ADDENDUM NO. 1

TO: PLANS AND SPECIFICATIONS FOR STATE OF MISSOURI

**Renovate Lobby and Restrooms 1st and 2nd Floor
Howerton State office Building
Jefferson City, Missouri
PROJECT NO.: O2339-01**

A-104

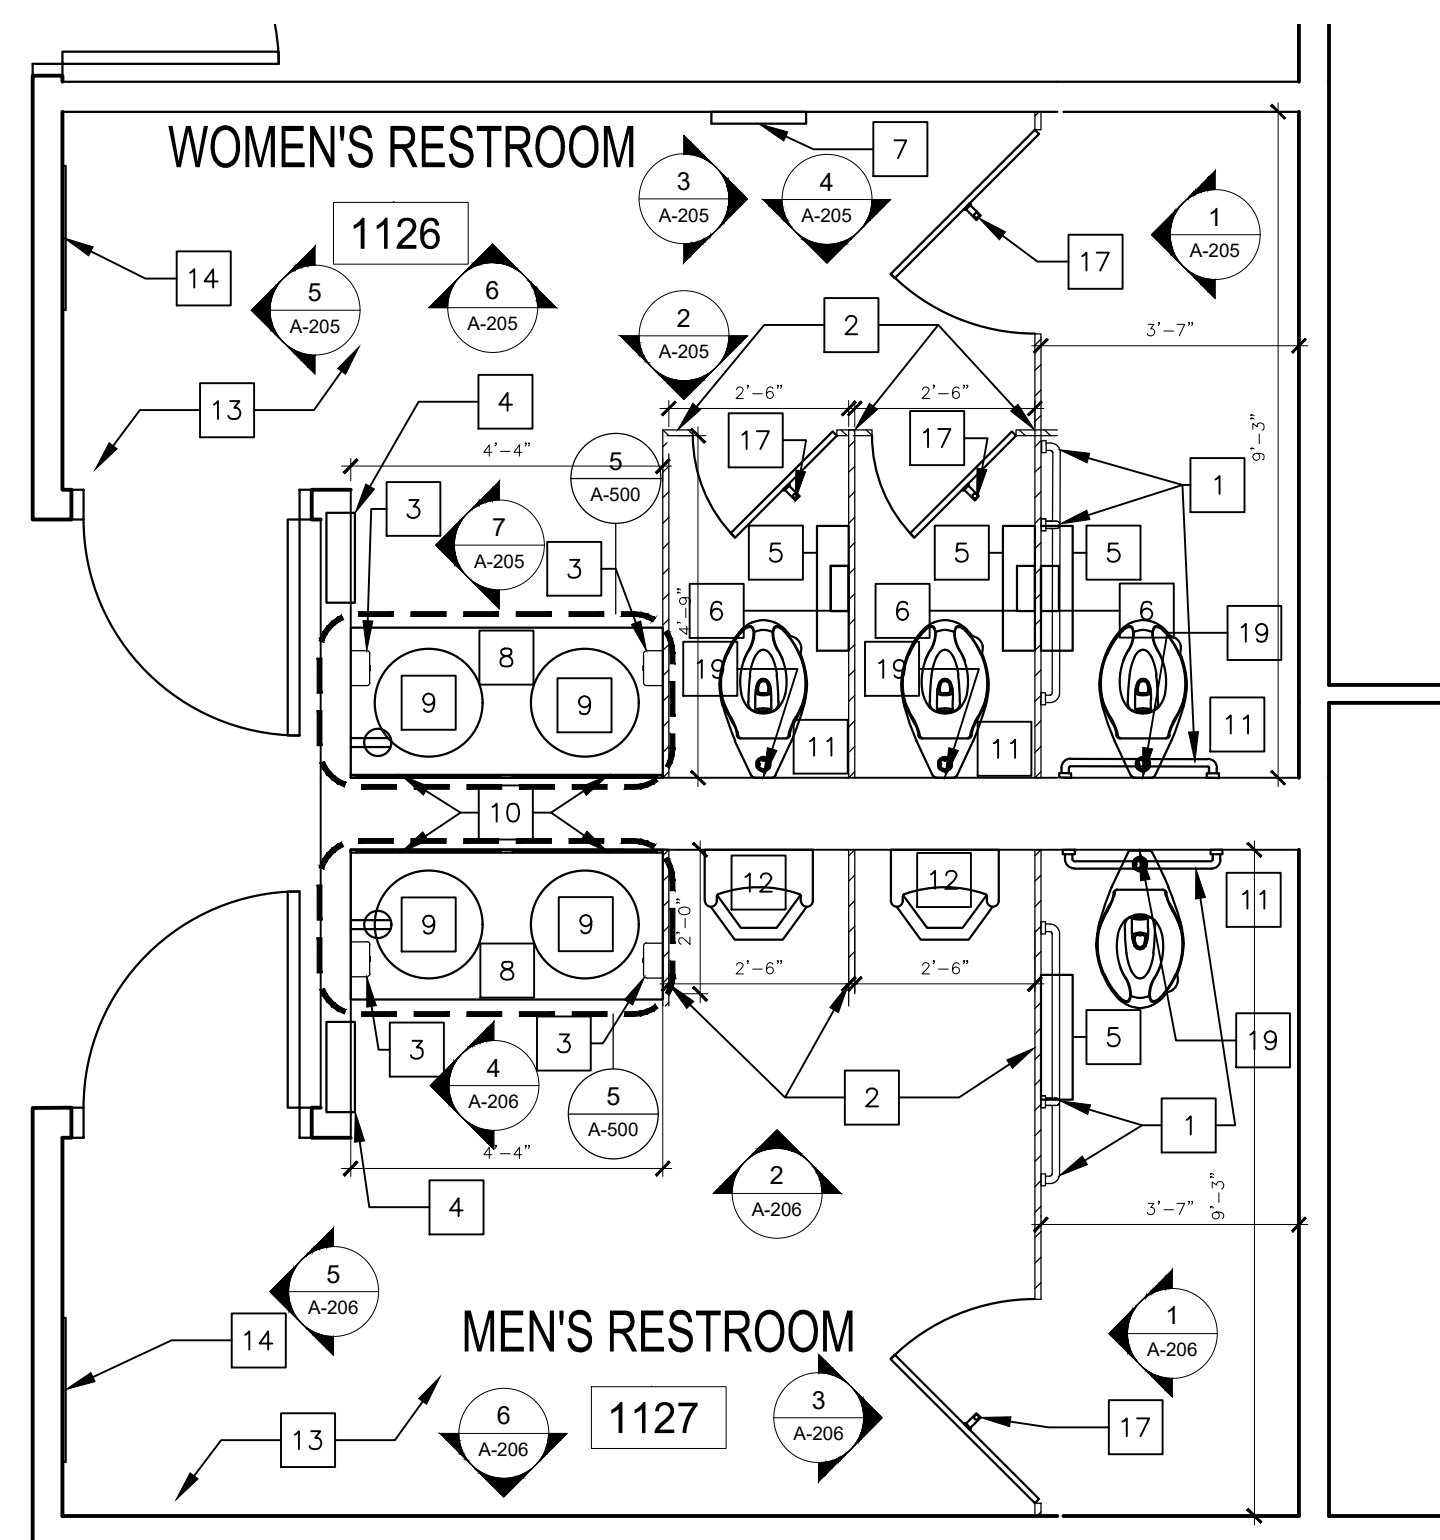
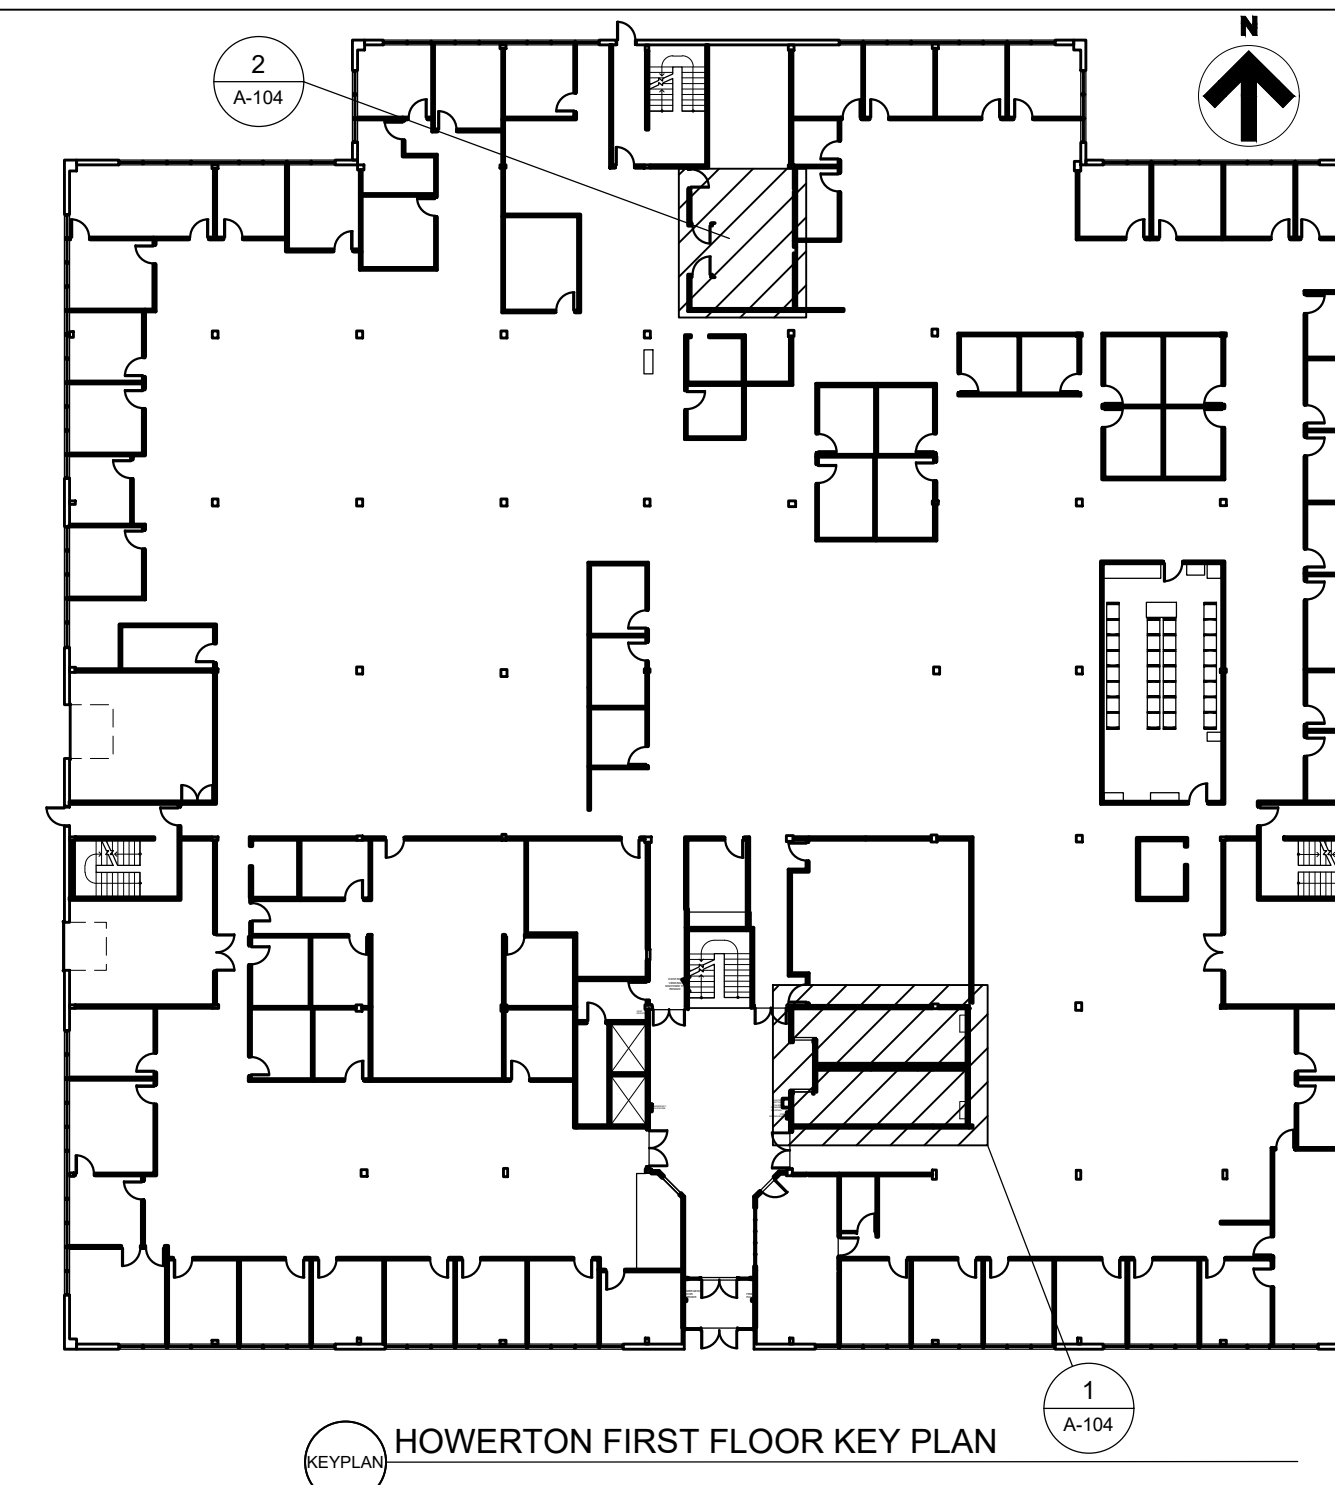
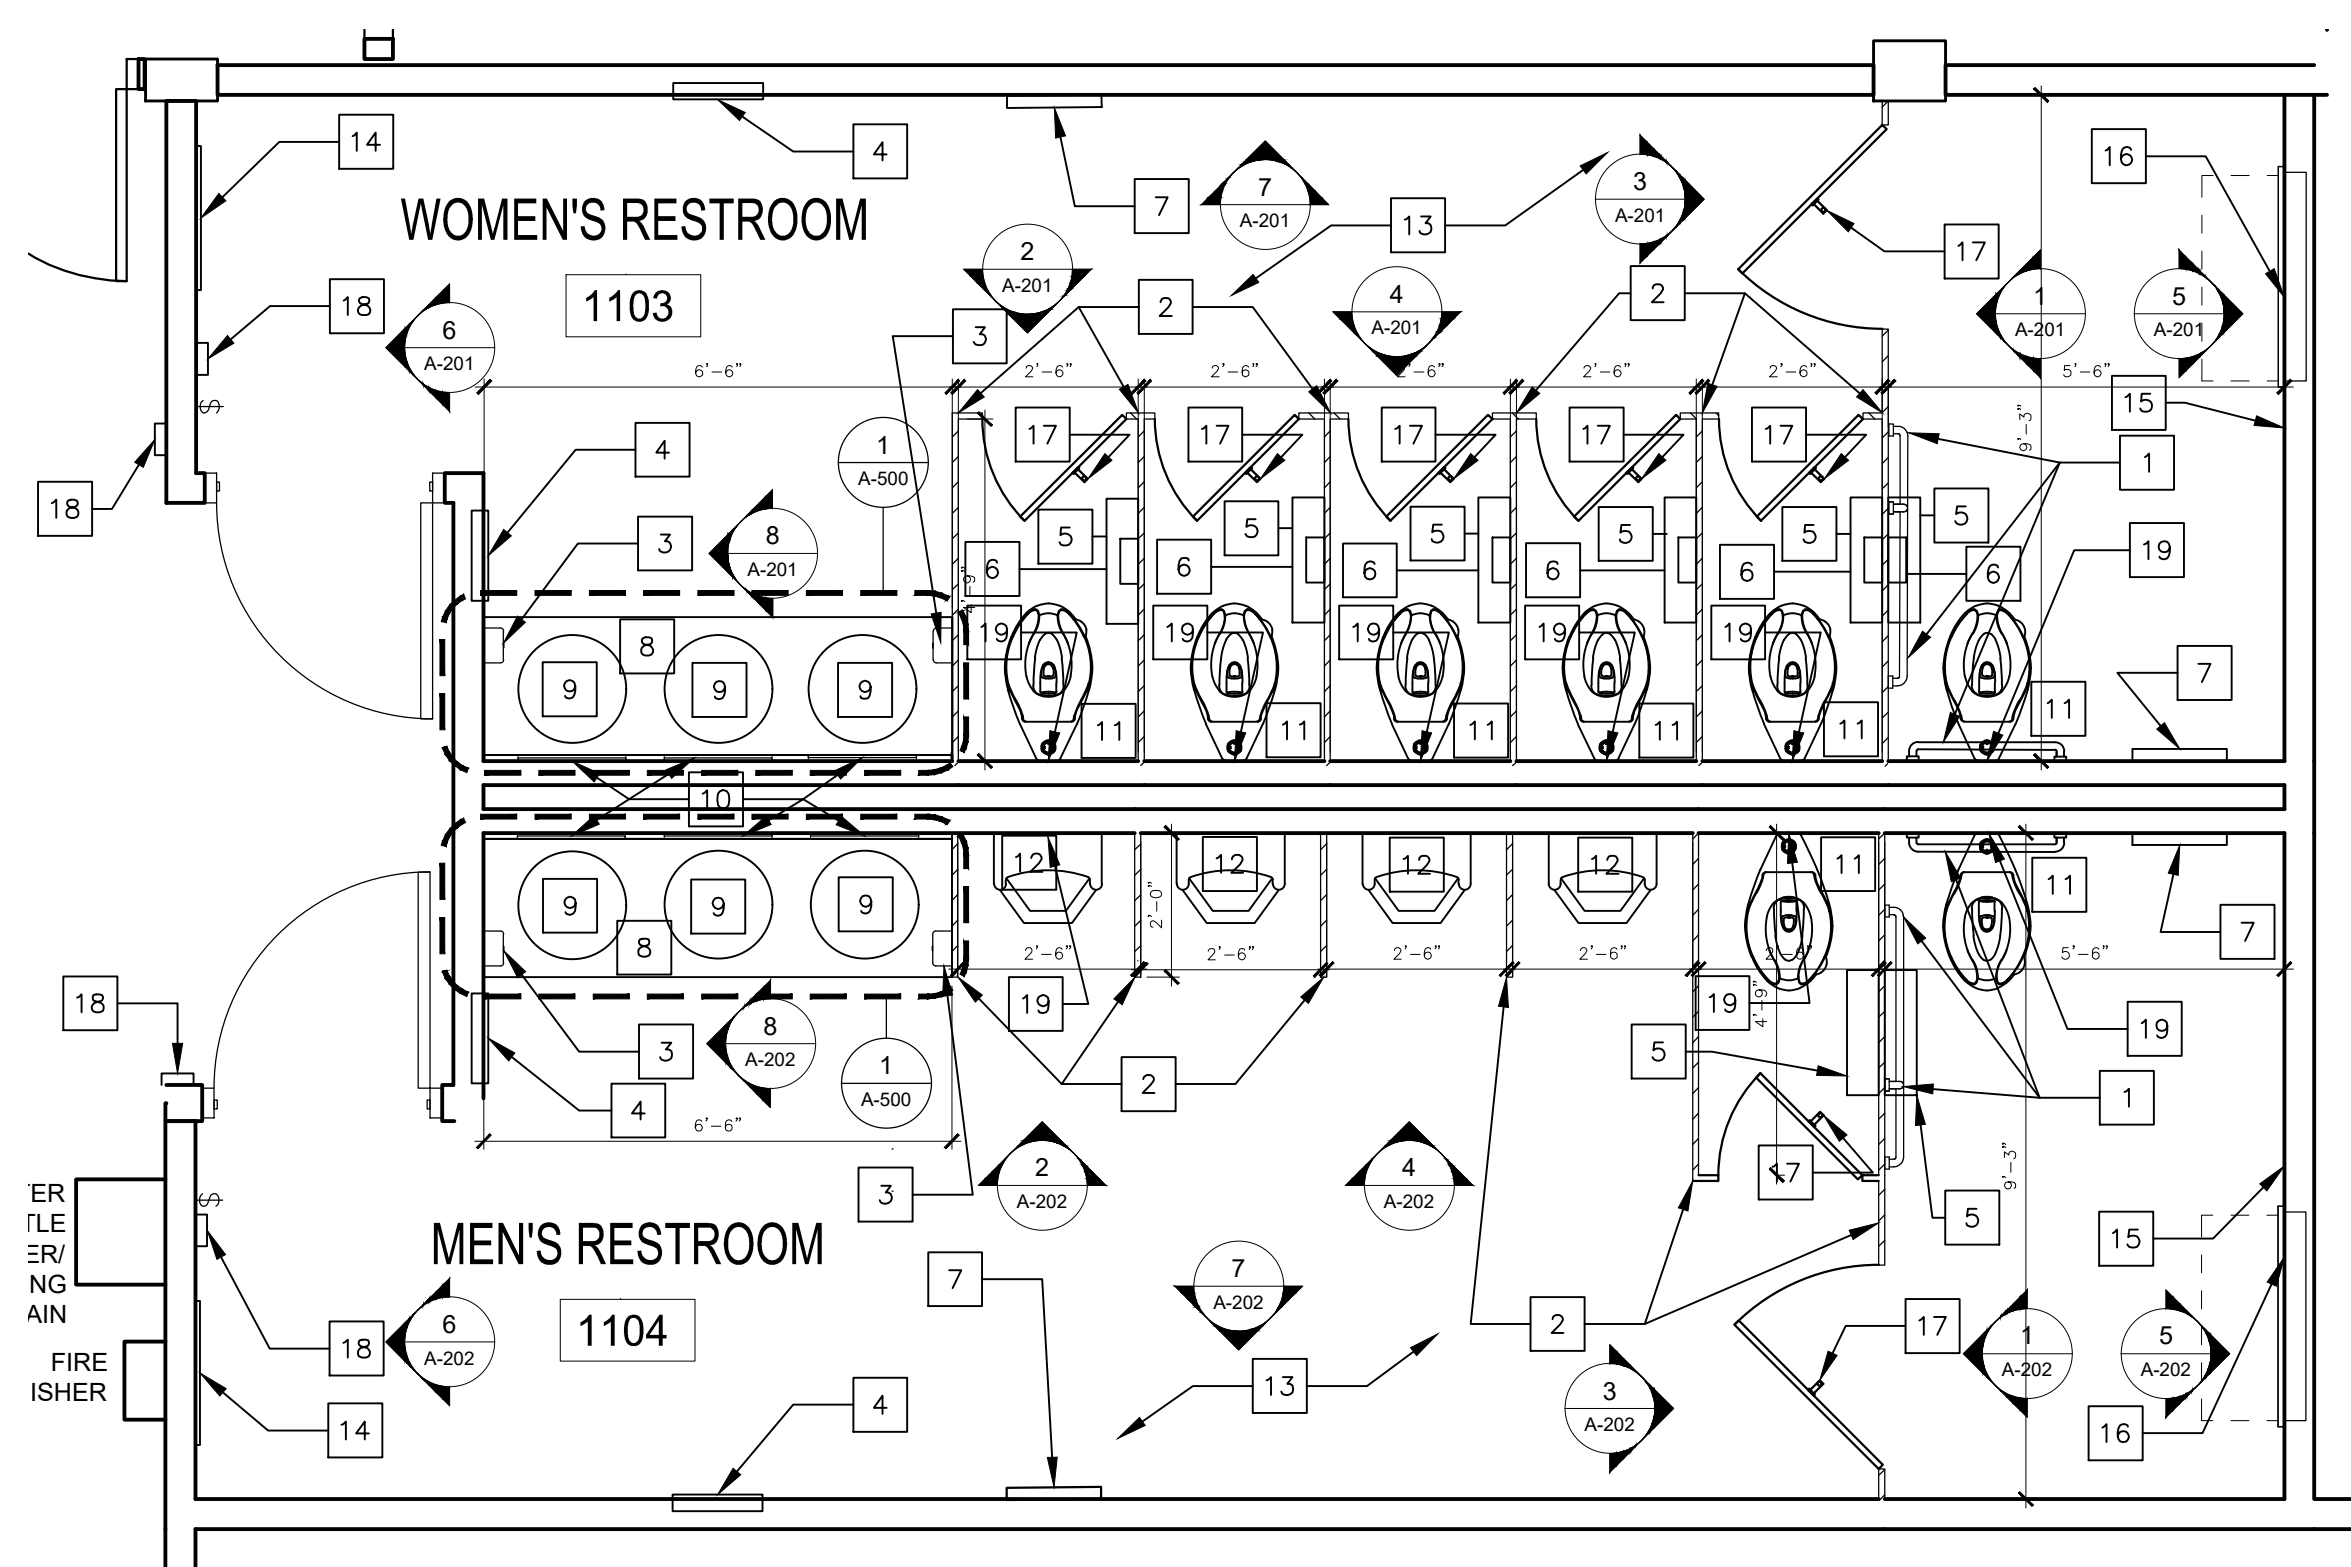
A-104

1. Restroom Fixture Schedule: Quantity changes per mark.
 - GB-1 Quantity changed from 2 to 4.
 - GB-2 Quantity changed from 2 to 4.
 - GB-3 Quantity changed from 2 to 4.
 - LAV-1 Quantity changed from 6 to 10.
 - TA-1 Quantity changed from 8 to 12.
 - TA-2 Quantity changed from 6 to 9.
 - TA-3 Quantity changed from 4 to 7.
 - TA-5 Quantity changed from 4 to 8.
 - TA-6 Quantity changed from 4 to 6.
 - TA-7 Quantity changed from 8 to 12.
 - TA-8 Quantity changed from 6 to 10.
 - TA-9 Quantity changed from 2 to 4.
 - TA-10 Quantity changed from 6 to 10.
 - WC-1 Quantity changed from 8 to 12.
 - WC-2 Quantity changed from 8 to 12.
 - UR-1 Quantity changed from 4 to 6.
 - UR-2 Quantity changed from 4 to 6.

2. Room Finish Schedule: B-1 color changed to Fudge 167.
